## ADDENDUM THREE

Ivy Flats  
205 Rumely Street  
LaPorte, IN 46350

Commission No.: F22131

Addendum Date: 29 April 2024

**D110**

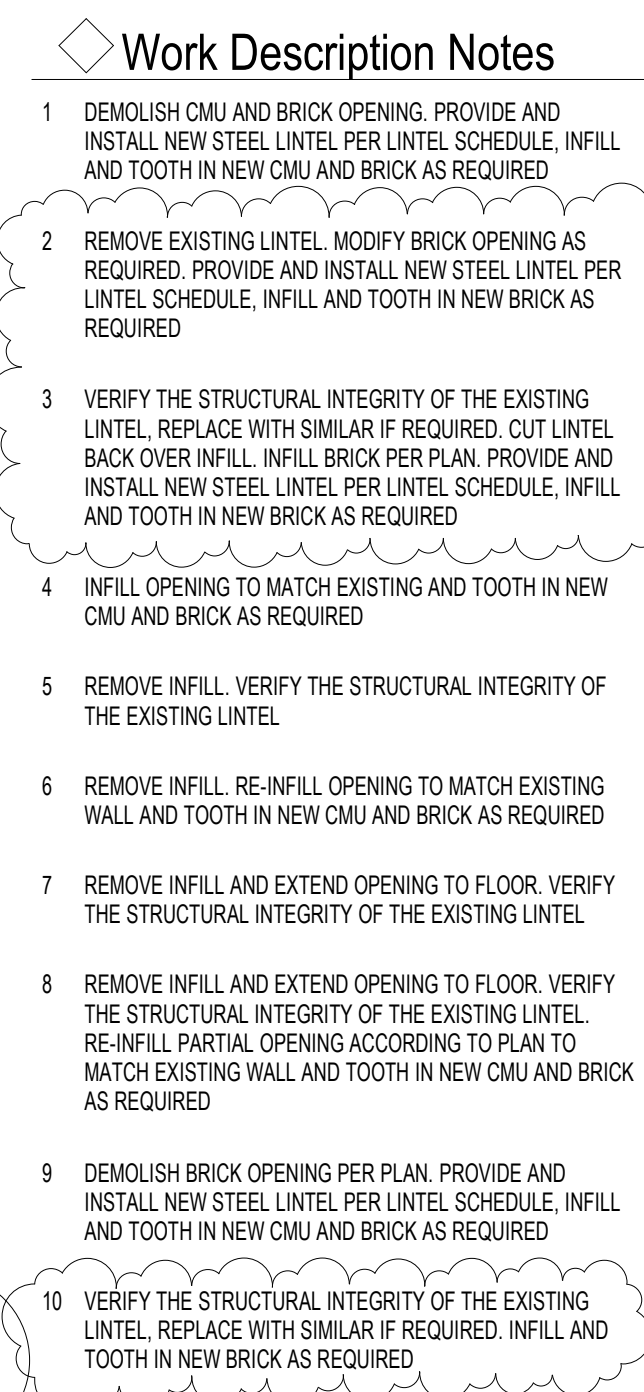
Please clarify whether dowels are required at concrete patching locations shown on D110. If dowels are required, please provide spacing.

- DEMOLITION NOTES: REVISE Demolition Note #1 to read:  
“DIMENSIONS ARE APPROXIMATE, TYP. ALL DIMENSIONS ARE TO BE FIELD VERIFIED.”
- 2/D110: **ADD** Detail #2 Trench Infill to the sheet.
- (9) locations have been **MODIFIED** for trenching/infill.

**Answer:** (MR) Detail 2/D110 has been added to Sheet D110 with dowels and spacing requirements.

A201

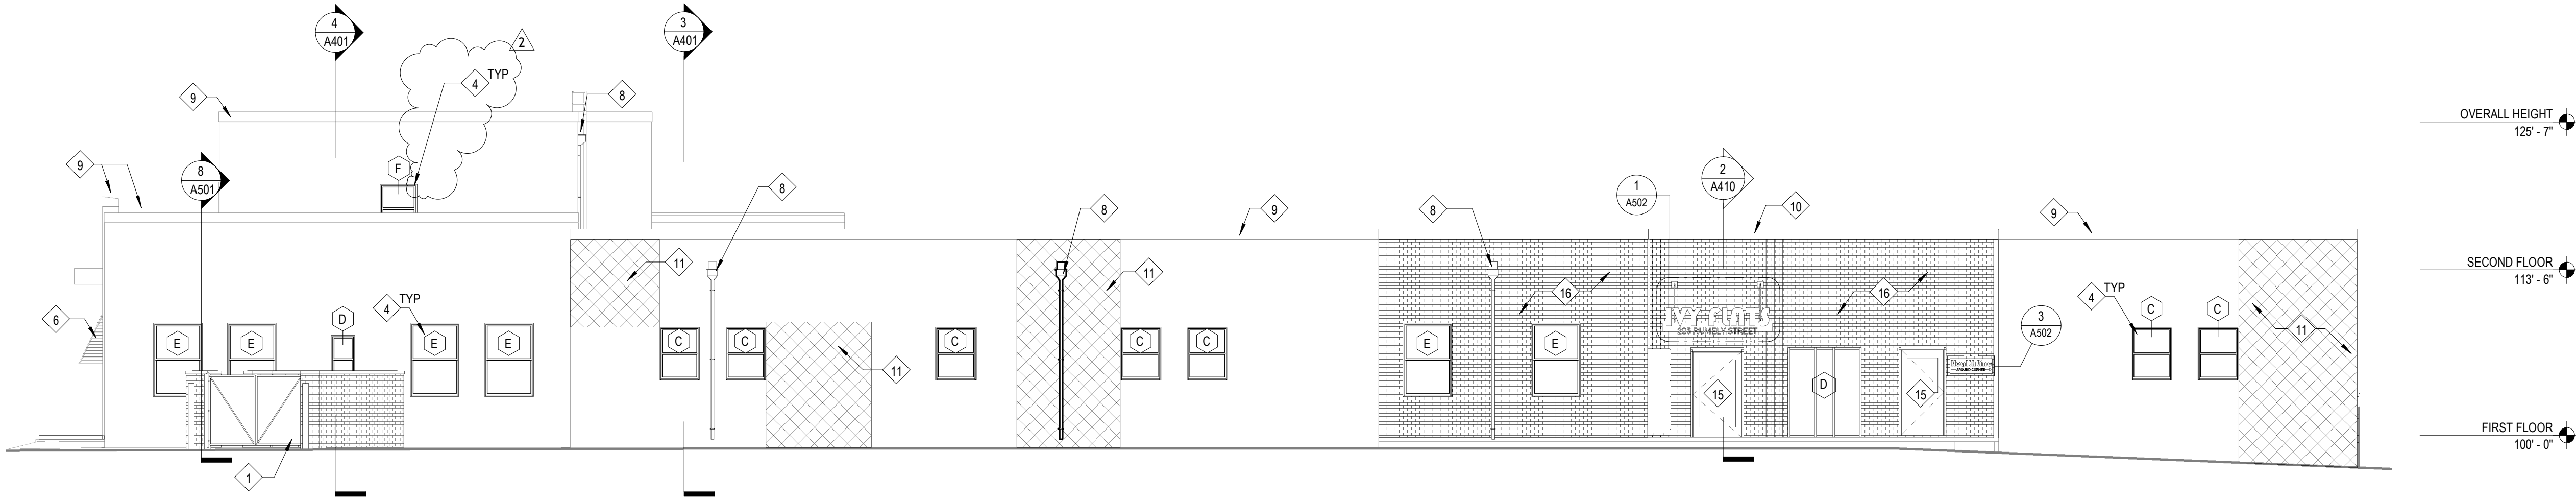
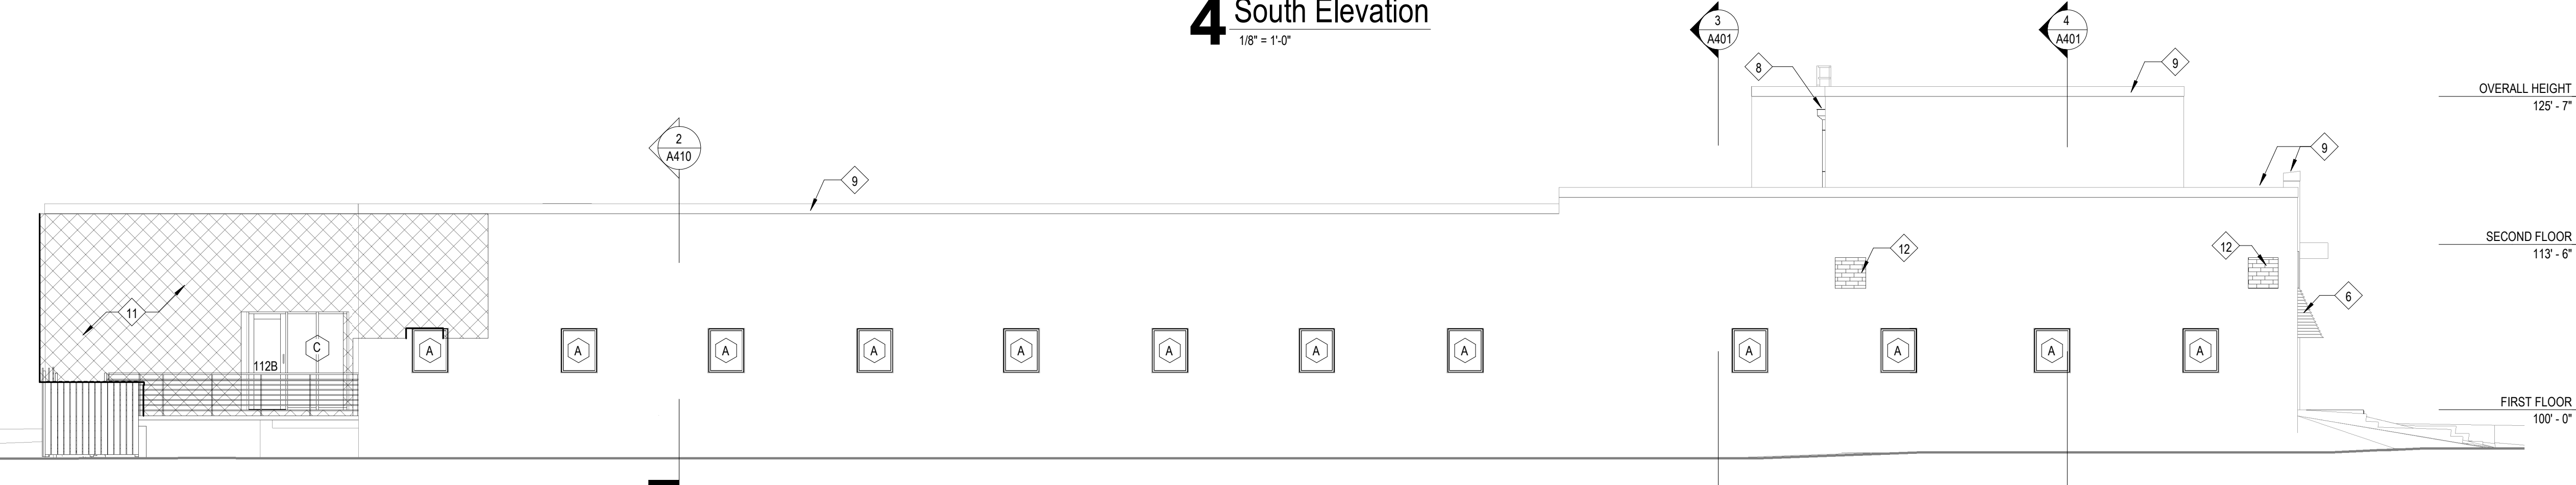
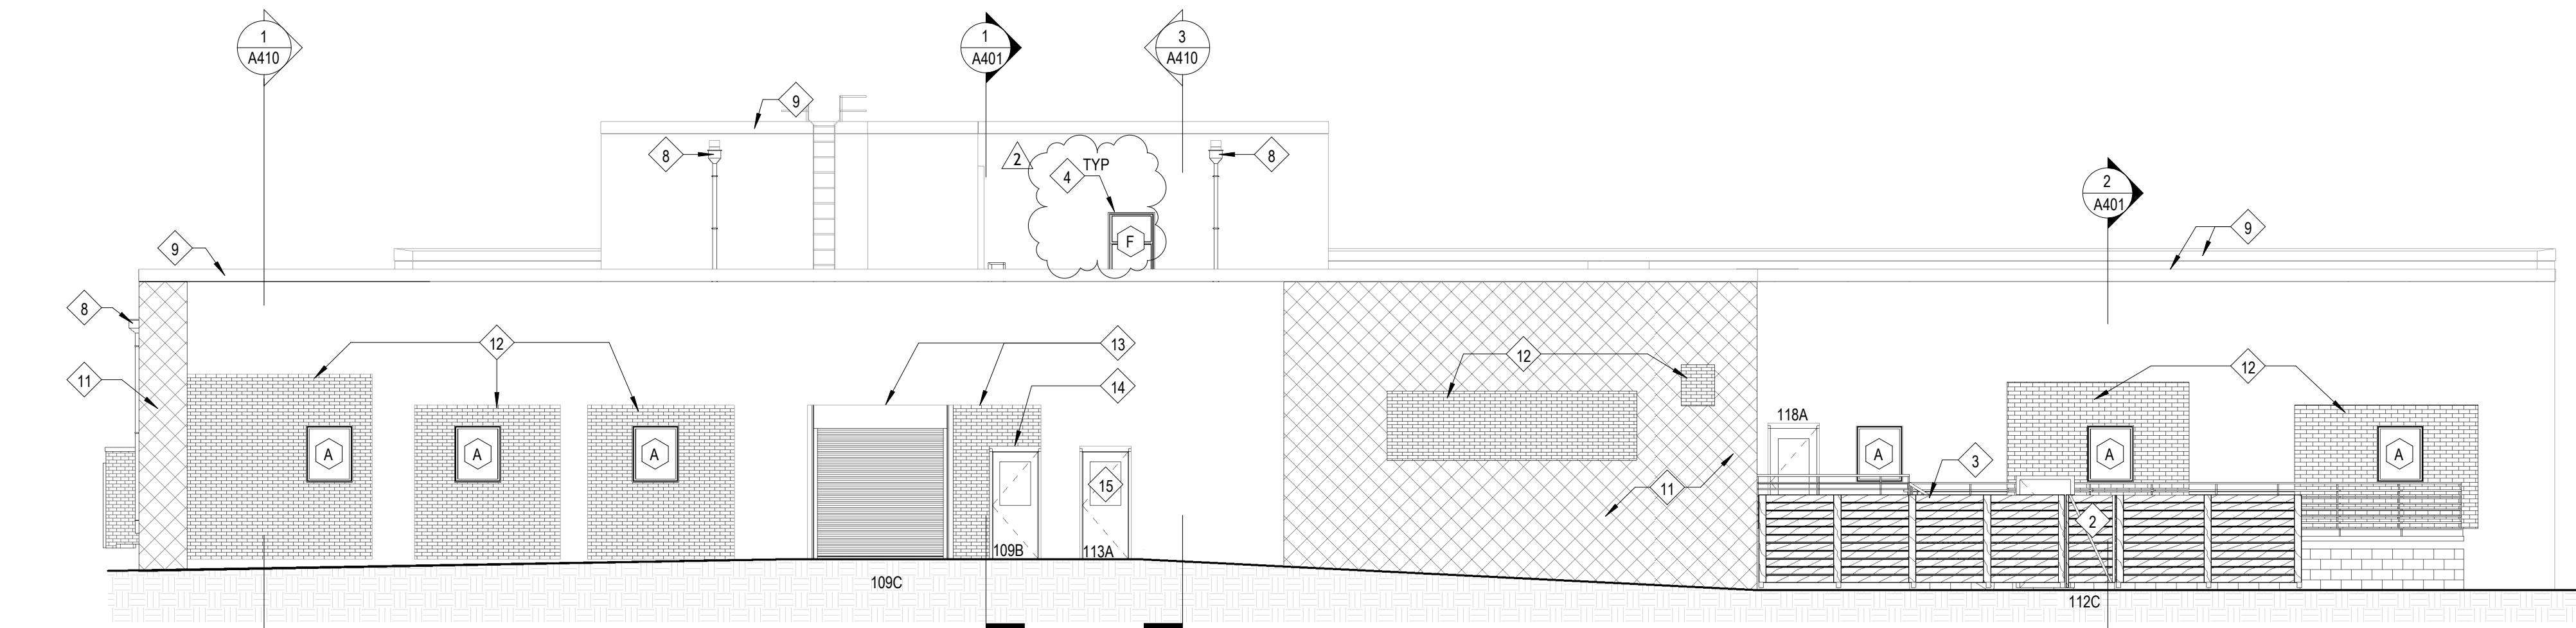
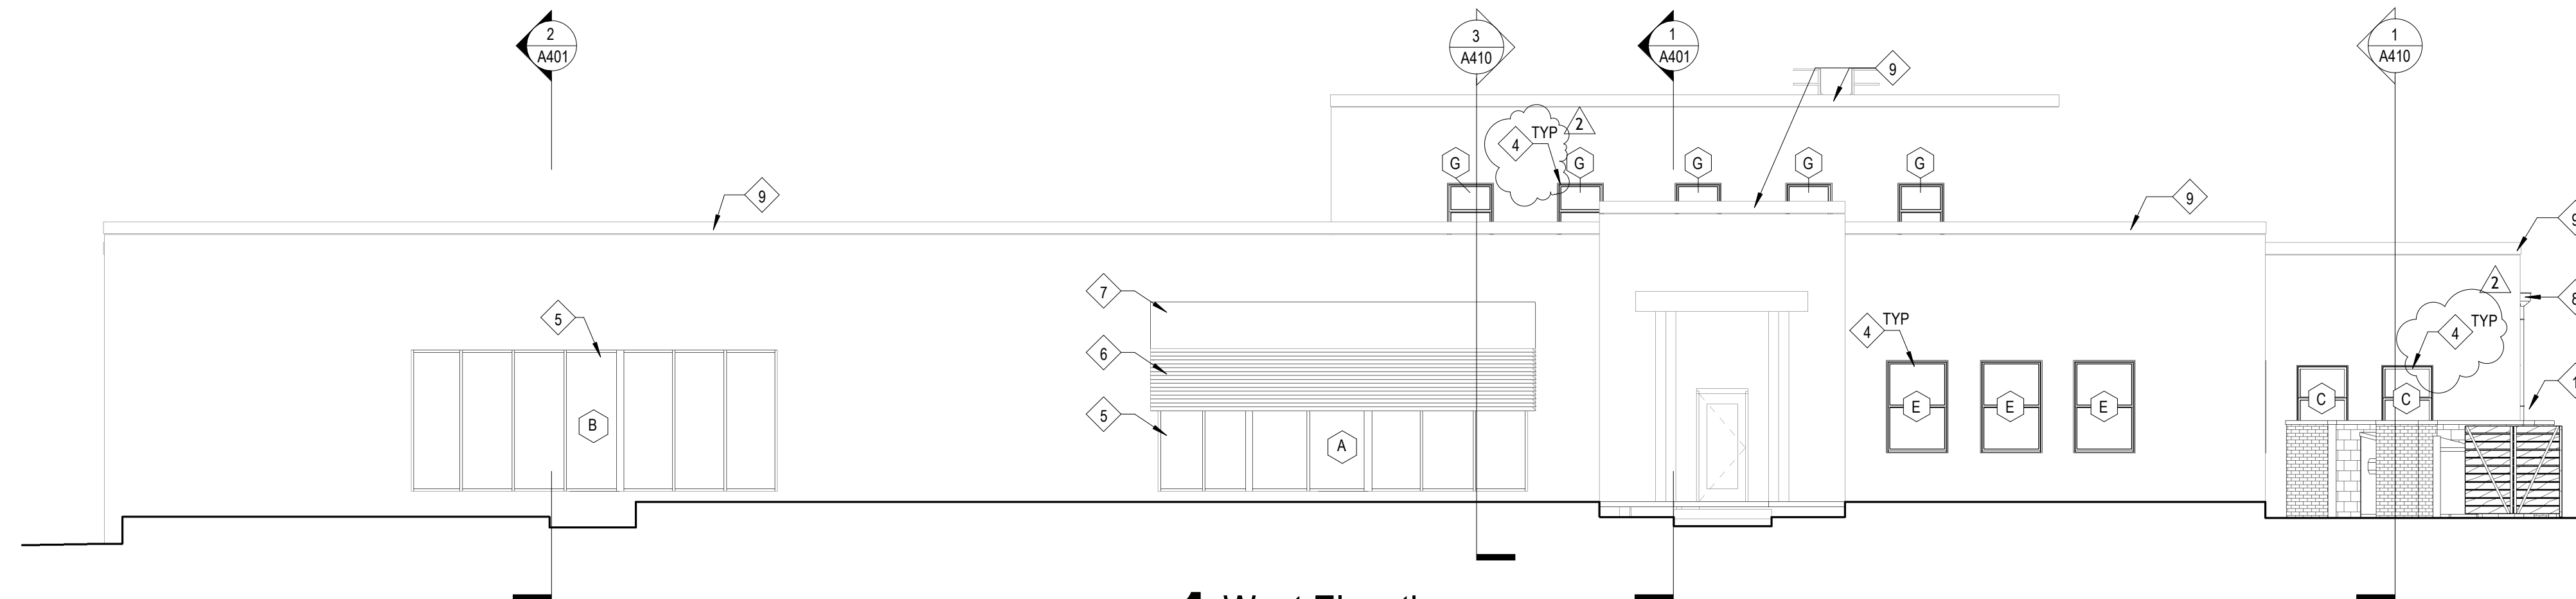
- 1/A201: (2) #4 Work Description Notes have been **ADDED** to the elevation.
- 2/A201: (1) #4 Work Description Note has been **ADDED** to the elevation.

- 4/A201: (1) #4 Work Description Note has been **ADDED** to the elevation.
